Project: IEEE P802.15 Study Group for Wireless Personal Area Networks (WPANs)

Submission Title: PSSS proposal – Parallel reuse of 2.4 GHz PHY for the sub-1-GHz bands

Re: PSSS mode for more even chiprates, simpler filter, and 250 kbit/s in 868 MHz

Purpose: Response to ballot comments to discuss potential modification of PSSS draft specification

IEEE802.15.4b-D1 Specification Draft: PSSS 206-440 868 MHz – BPSK/ASK (15/32 bit/s/Hz)¹

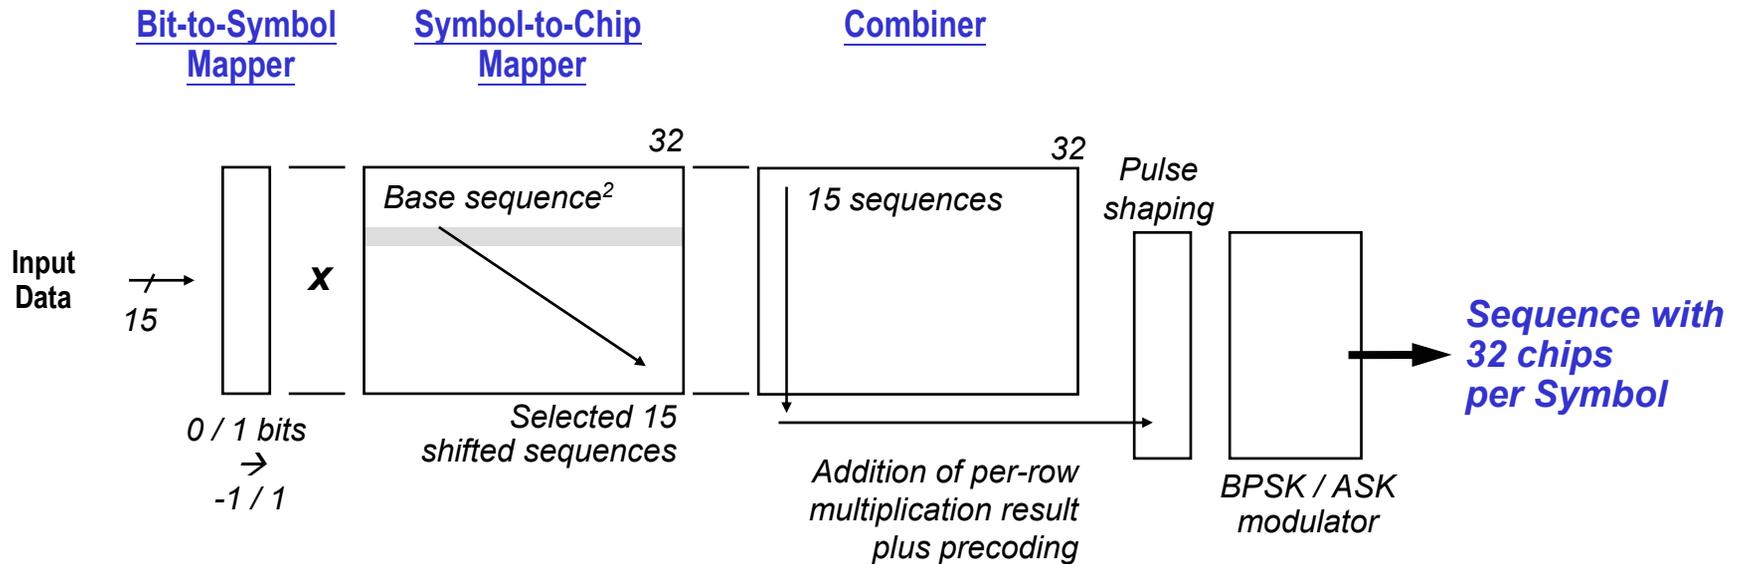
...addition of multiple parallel sequences instead of selection of single sequence

2: Use of single base sequence simplifies implementation in Rx

No modification of the basic PSSS model: PSSS 250-400 868 MHz – BPSK/ASK (20/32 bit/s/Hz)

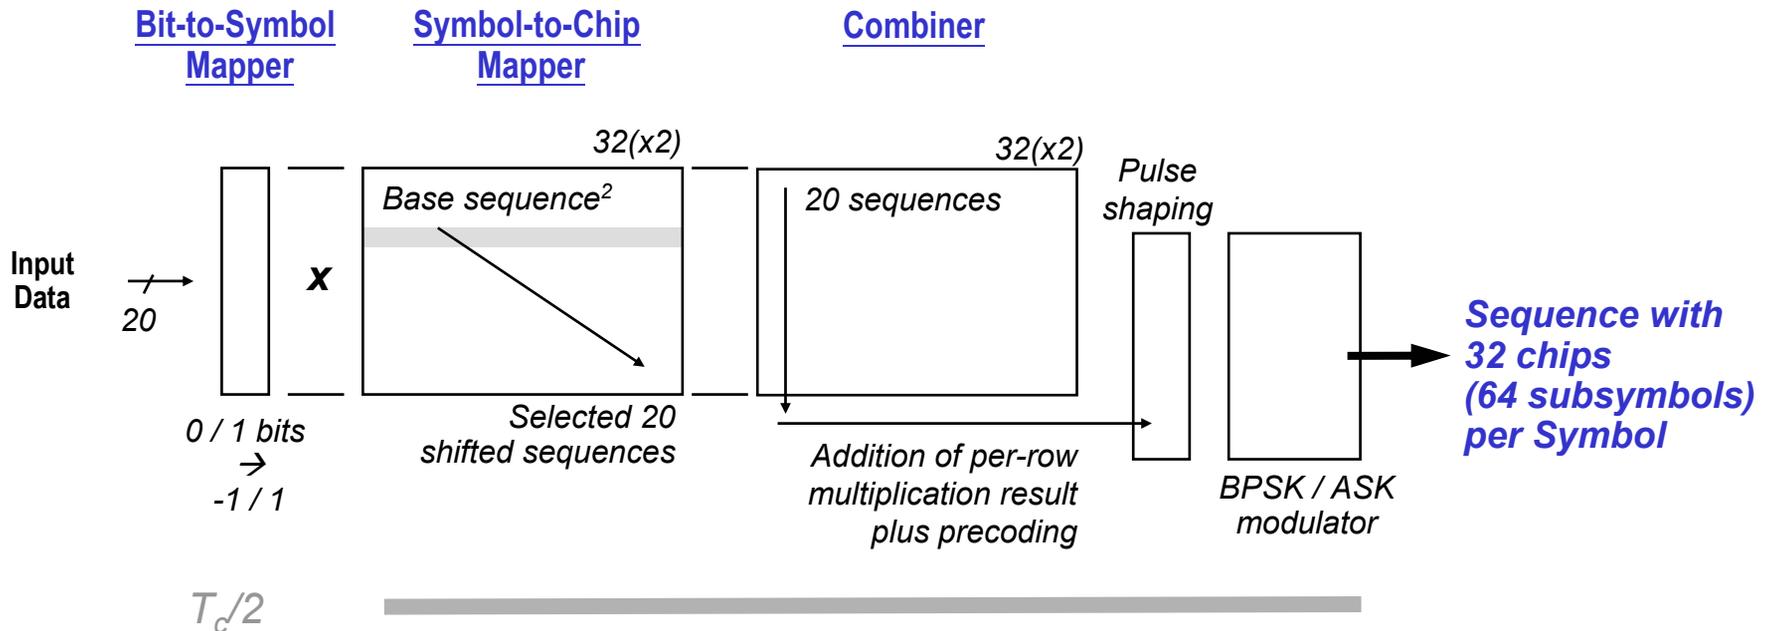
Shifting of sequences by 3 instead of 4 subchips enables addition of sequences to achieve 250 kbit/s and 400 kbps

- 2 sub-chips per chip – basic chip rate of coding scheme is unchanged
- Addition per sub-chip for multivalue encoding – no other changes of PSSS model

- **No increase of Tx complexity in real-world implementation –**
 - Oversampling used for baseband filtering to achieve PSD compliance anyhow
 - No change in number of chips per symbol – no increase in coding table sizes
- **Simpler baseband filter sufficient due to lower chiprate**
- **No change in Rx processing required**

Preamble Detection with current Barker Code

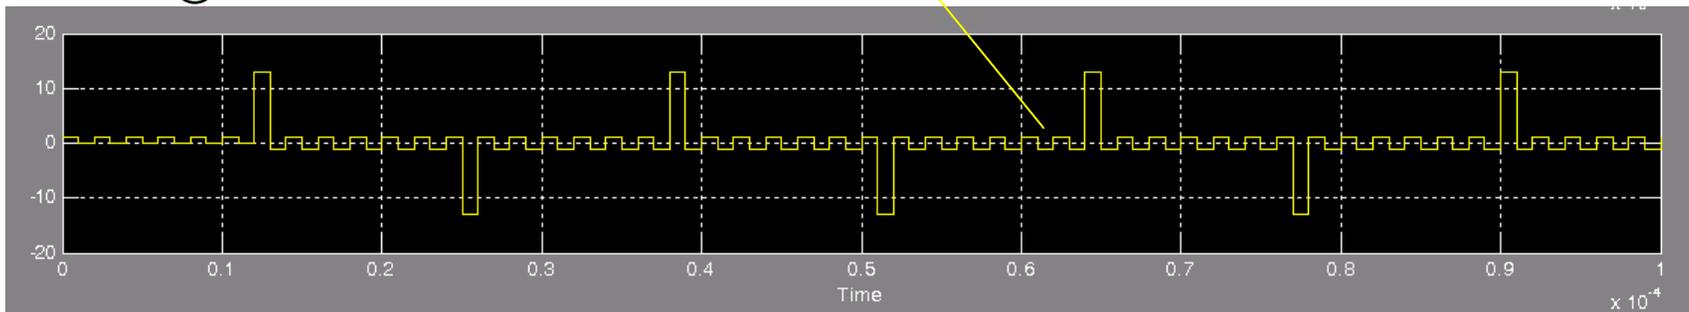
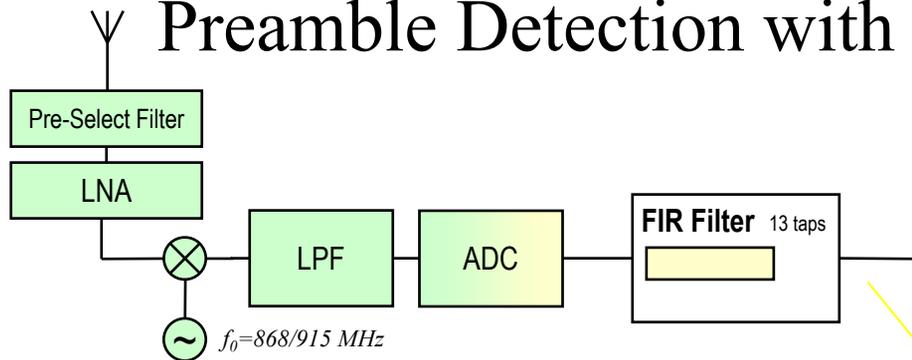
- When detecting the current barker code based preamble with FIR filter, the signal coming out of the FIR filter has side slopes limited to ± 1 .
- Advantages:
 - It is DC free
- Disadvantages:
 - Side slopes causes a mismatch of the energy maximum detection for multipath fading channels.
 - Two FIR filters needed, one for preamble detection (13 chip barker code), one for PSSS decoding (31 chip m-sequence).

Preamble Detection with Sequence 0 of the PSSS Coding Table as preamble

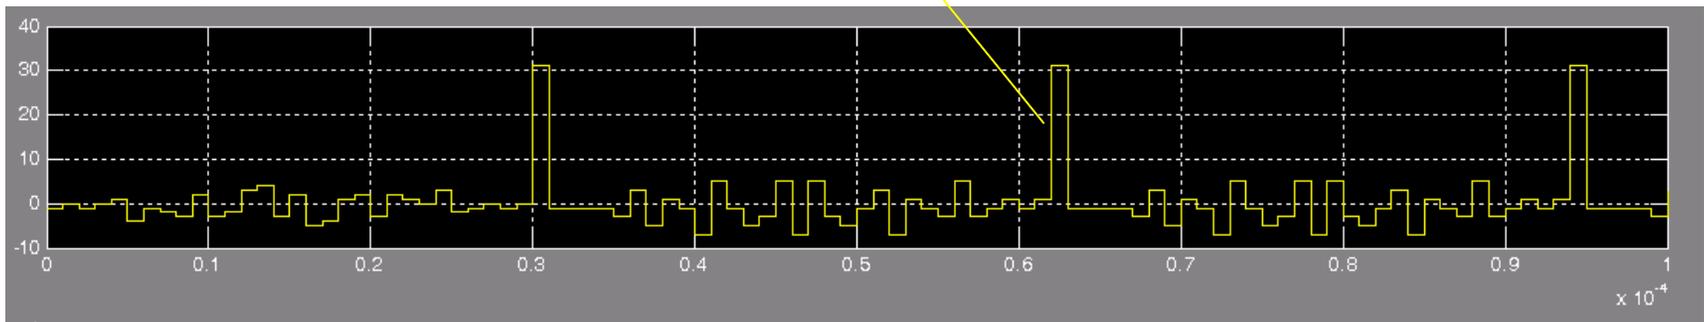
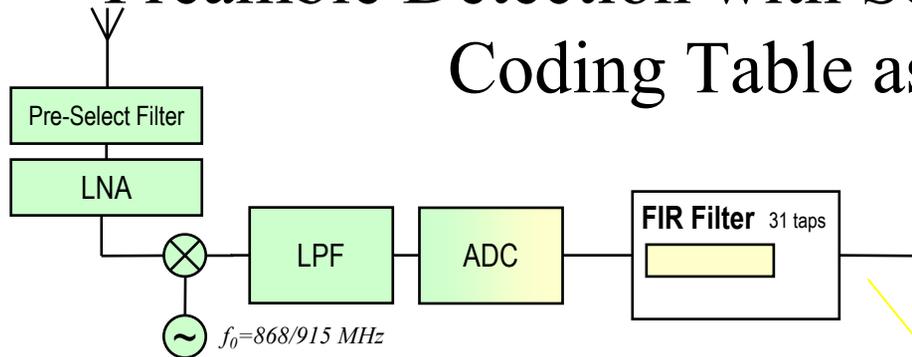
- When detecting the preamble, based on repeated sequence 0 with FIR filter, the signal coming out of the FIR filter has side slopes limited to +5/-6.
- Advantages:
 - Use of just one FIR filter or correlator for preamble detection and PSSS decoding.
 - 32 chip long preamble code.
 - DC free
- Disadvantages:
 - Side slopes causes a mismatch of the energy maximum detection for multipath fading channels.

- We propose to use a preamble with repeated Sequence 0 or m-sequence c_0/c_{0dc_free} for lowest design complexity and highest performance.
- If length of 32 chips is needed for preamble code the usage of Sequence 0 is the best solution.

Preamble Detection with M-Sequence C_0 as preamble

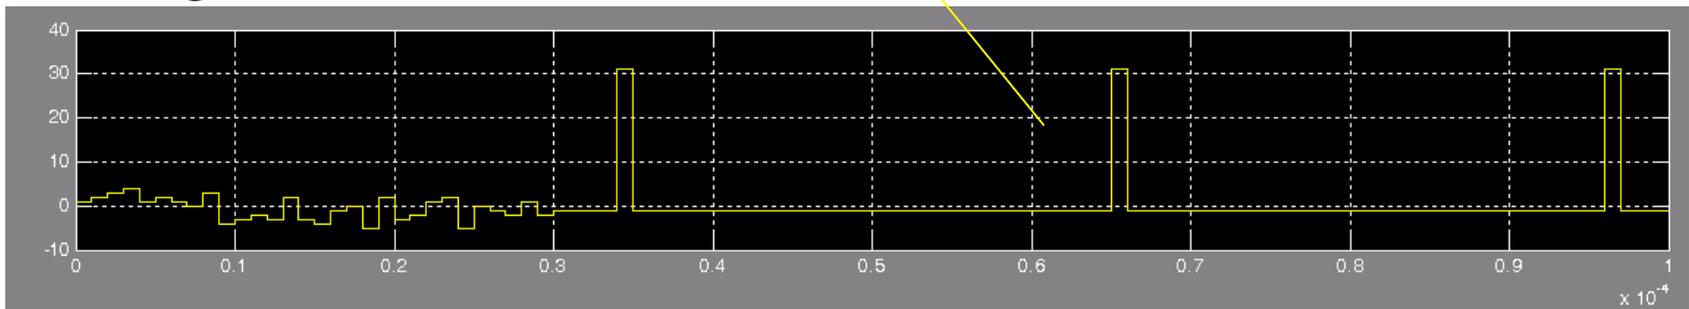
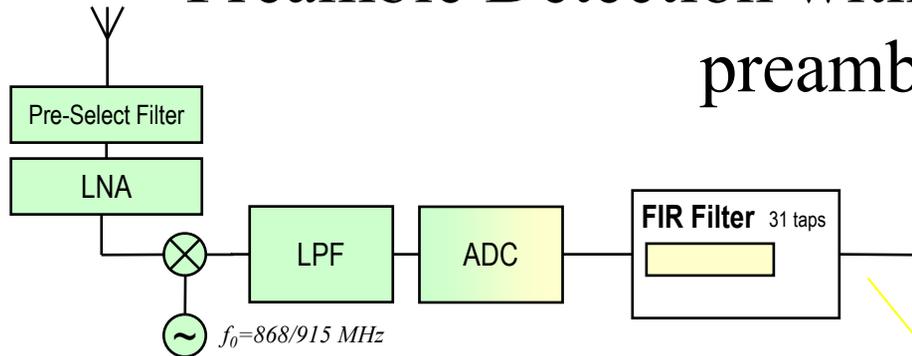
- When detecting the preamble, based on repeated m-sequence c_0 with FIR filter, the signal coming out of the FIR filter has no side slopes, when the first m-sequence c_0 has passed the FIR filter.
- Advantages:
 - Use of just one FIR filter or correlator for preamble detection and PSSS decoding.
 - No side slopes.
 - Optimal maxima detection for multipath fading channels possible.
- Disadvantages:
 - Not DC free.
 - Length of 31 chips instead of 32 chips

Preamble Detection with M-Sequence c_{0dc_free} as preamble

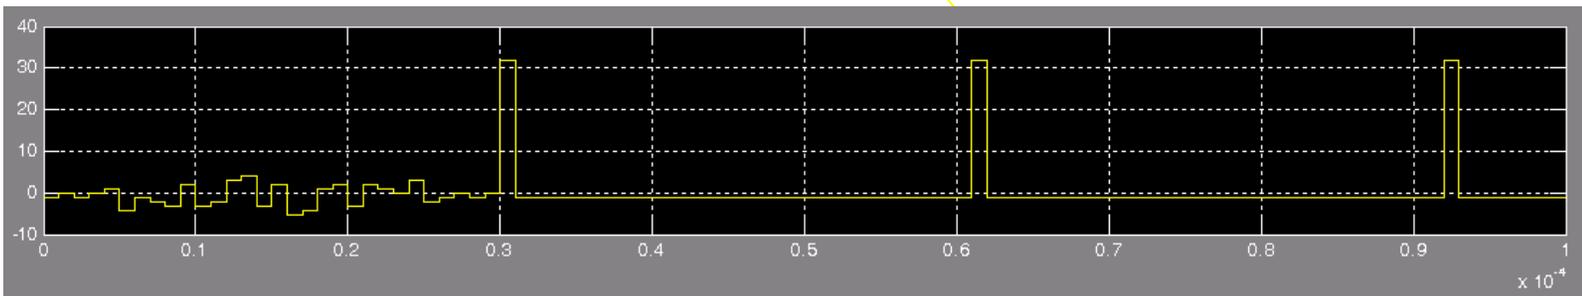
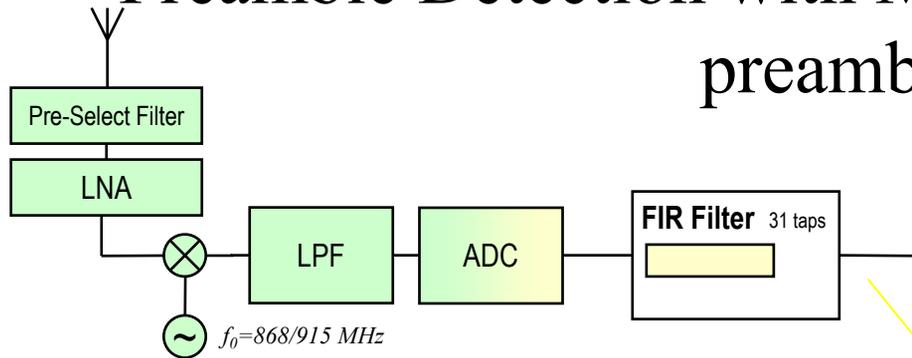
- When detecting the preamble, based on repeated m-sequence c_{0dc_free} with FIR filter, the signal coming out of the FIR filter has no side slopes, when the first m-sequence c_{0dc_free} has passed the FIR filter.
- Advantages:
 - Use of just one FIR filter or correlator for preamble detection and PSSS decoding.
 - No side slopes.
 - DC free.
 - Optimal maxima detection for multipath fading channels possible.
- Disadvantages:
 - 31 chip length instead of 32 chips as for the PSSS codes

PER Performance PSSS 250-400 868 MHz (BPSK/ASK) – Discrete Exponential Channel, 250ns RMS Delay Spread

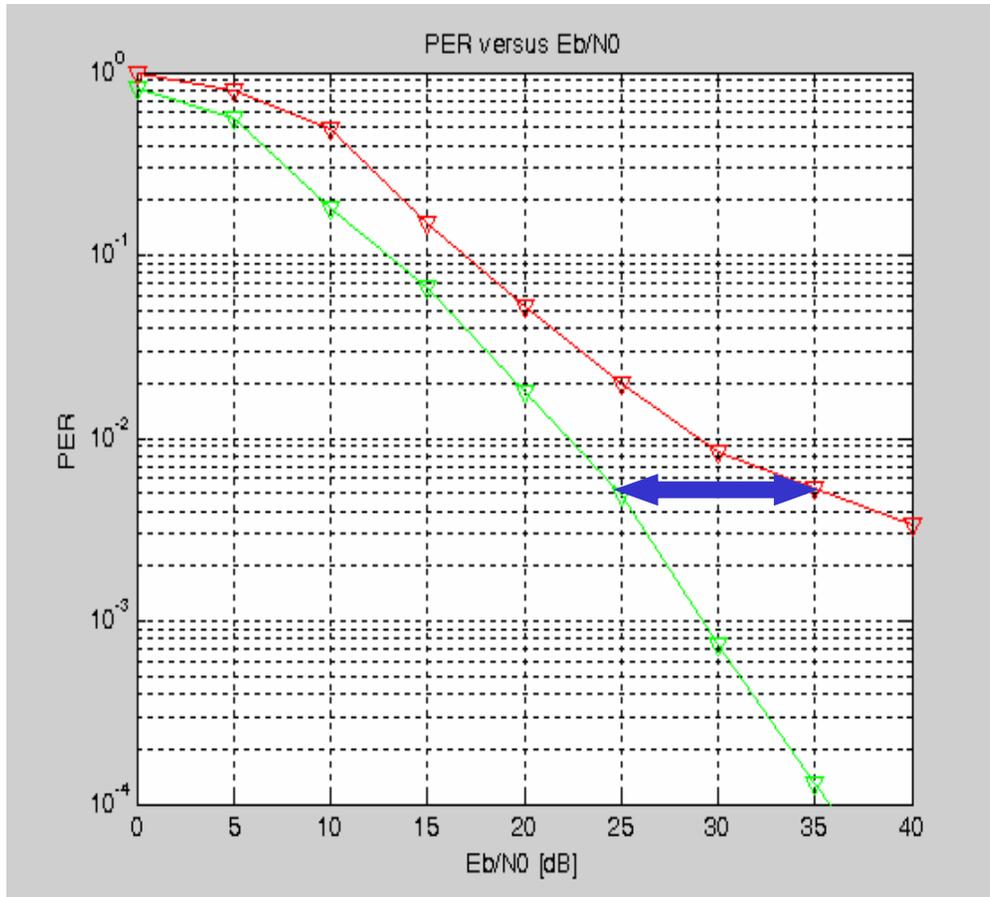
Comparison to PSSS 206-440 868 MHz

- No visible degradation of performance

PER Performance PSSS 250-400 868 MHz (BPSK/ASK) – Discrete Exponential Channel, 370ns RMS Delay Spread

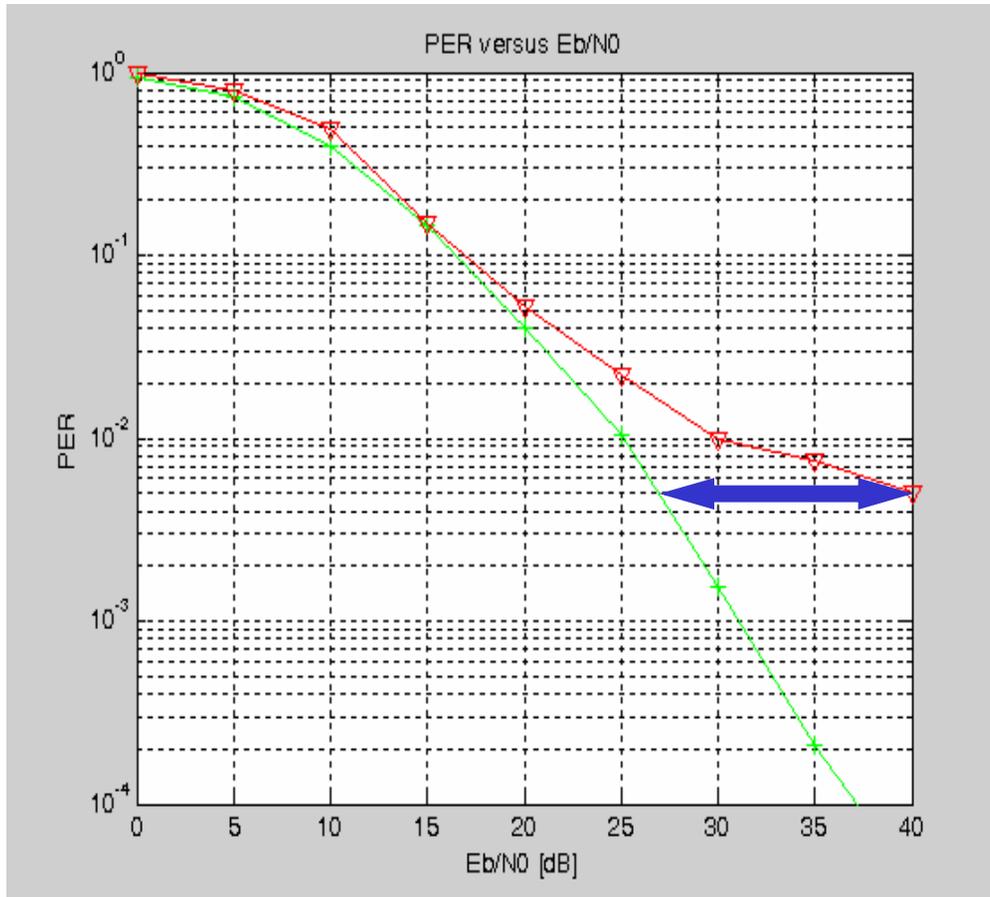
Comparison to PSSS 206-440 868 MHz

- No visible degradation of performance
